CITY PLANNING COMMISSION

- APPLICATION:
1. Special Permit to remodel an existing two-unit apartment complex into four units in the General Commercial (C-2) zone (Sec. 2-B-1 and 2-E-5)
 2. Variance to reduce the required minimum planter width from four feet to 2.5 feet (Sec. 6-D-5)

LOCATION: 2030 'H' Street

APPLC. NO. P84-102

EXHIBIT F

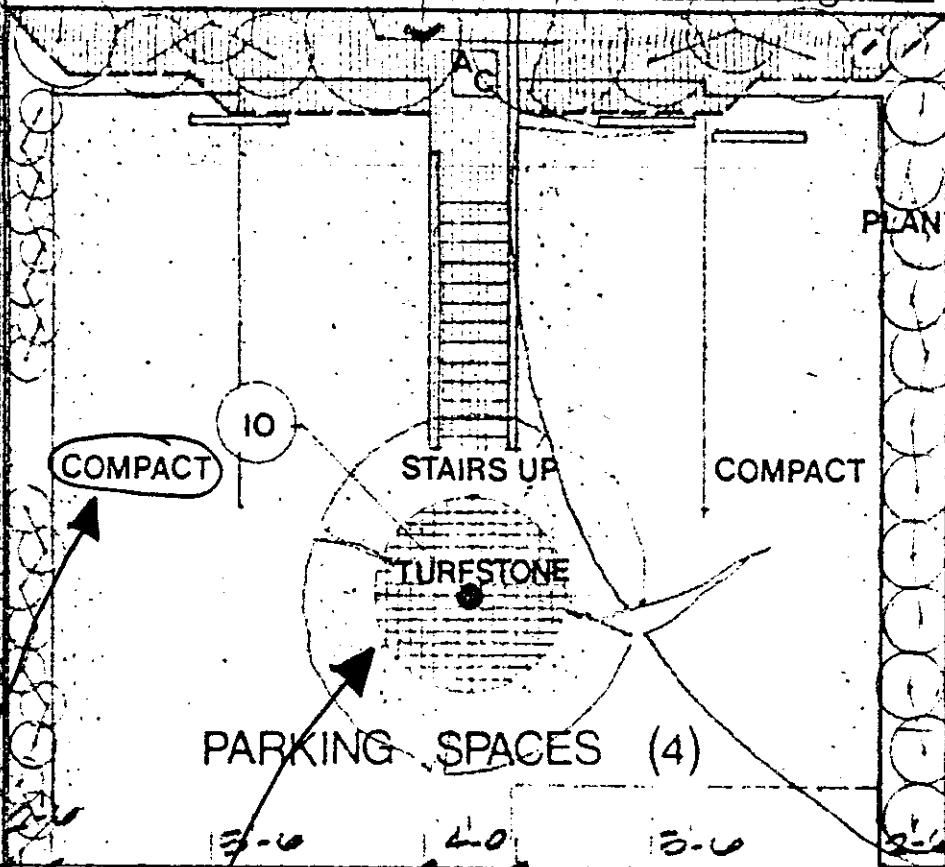
- a. Minimum required driveway width is 24 feet. Driveway must meet this requirement;
 - b. Proposed plum tree occupies required maneuvering space;
 - c. Car in western stall will have difficulty getting out of stall;

- d. Sidewalk planter is too narrow after curbing is installed around soil area;
 - e. Tight stalls against the narrow stairway seems rather hazardous.

6. Staff, however, has concerns regarding the design of the proposed parking area to the rear of the building. The applicant has designed the parking lot with a 2.5 foot wide planter on the street side and a 2.5 foot wide planter along the west property line (Exhibit F). The purpose of the planter along the west property line is to provide a dirt area to plant crawling vegetation on a lattice support that would eventually cover the bare wall of the adjacent building. The applicant proposes to create a 30-inch high formal boxwood hedge in the 2.5 foot street side planter (no curbing). The applicant believes that such planting would create a well landscaped courtyard and is requesting a variance to reduce the minimum planter width adjacent to 21st Street.

Variance requested by applicant to reduce width of this planter

Driveway does not meet minimum width requirements.

- * Enough room for standard size stall and maneuvering area. Not a compact.
- * Tree interferes with car maneuvering area. must be removed.
- * Planter encroaches into required $\frac{1}{2}$ 26' of maneuvering width. Planter must be revised.

The parking area, however, can be designed to accommodate the minimum four foot wide planter and one foot of bumper curb required for parking areas along public streets (Exhibit G). The Zoning Ordinance requires a minimum of four feet of soil area for planters adjacent to public streets as this width is necessary to insure healthy and effective screening shrubs. The applicant's 2.5 foot wide planter design would jeopardize the health of the shrubs located in this street side planter. In addition, it is possible that the vegetation proposed by the applicant along the west property line would be damaged by cars maneuvering in and out of the adjacent parking space. The site would be better served by having the required planter width along the public street rather than splitting the planter area in two. Staff, therefore, recommends denial of the variance request.

7. Planning staff agrees with the comments of the Traffic Engineering Division that the parking lot driveway should be widened to 24 feet to accommodate two-way traffic and that the plum tree proposed for the middle of the area be removed as it impedes effective automobile maneuvering. The planter along the south side of the parking area will also need to be revised so that it does not interfere with the required 26 feet of automobile maneuvering width. While the applicant is only required to provide two parking spaces for the two-unit residential expansion, a four-car parking lot is preferred as it will relieve parking congestion in the area and insure building residents a place to park. Staff recommends that a sign be placed at the driveway entrance noting that the parking lot is for the residential use only and not for the patrons of the commercial uses on the subject site.

EXHIBIT G

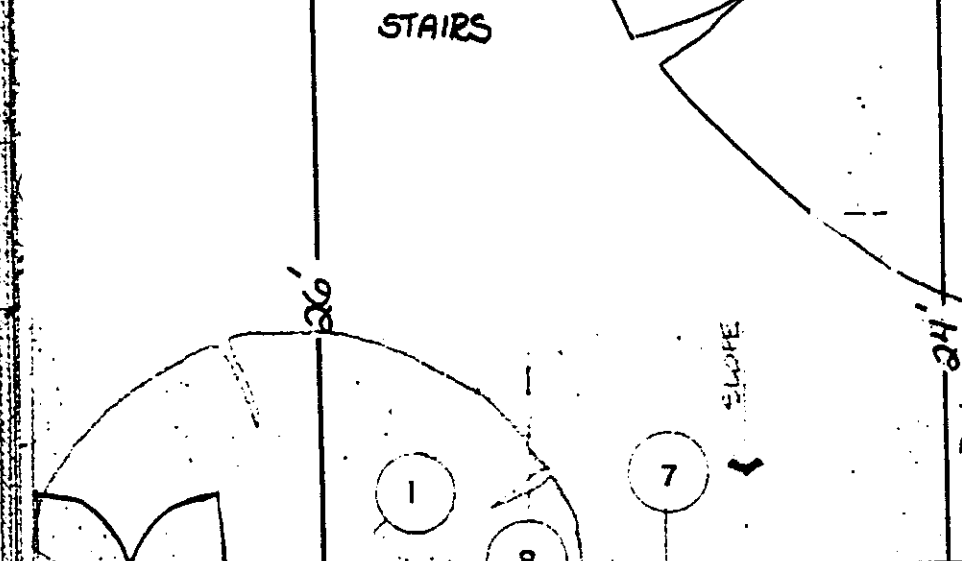
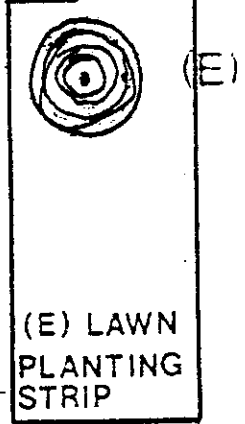
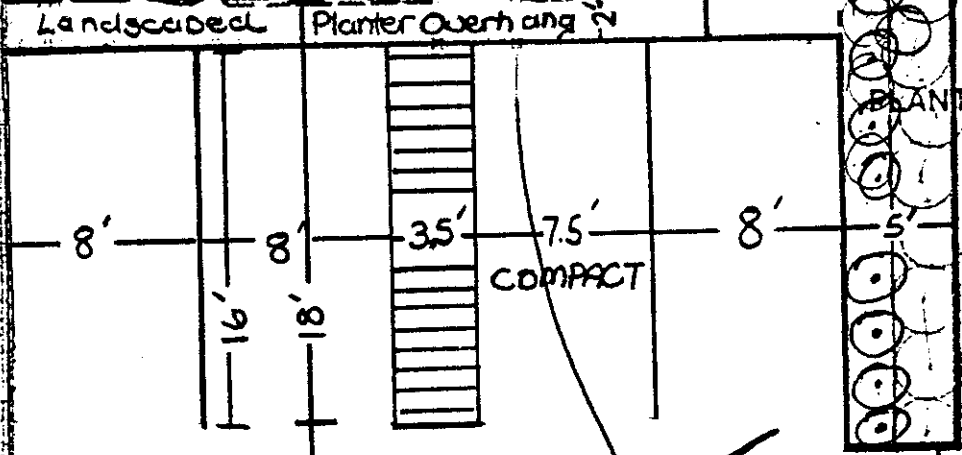
Staff Revision

Tree to be relocated
in planter

Planter wide enough to add second tree for shading purposes if necessary

24' Driveway
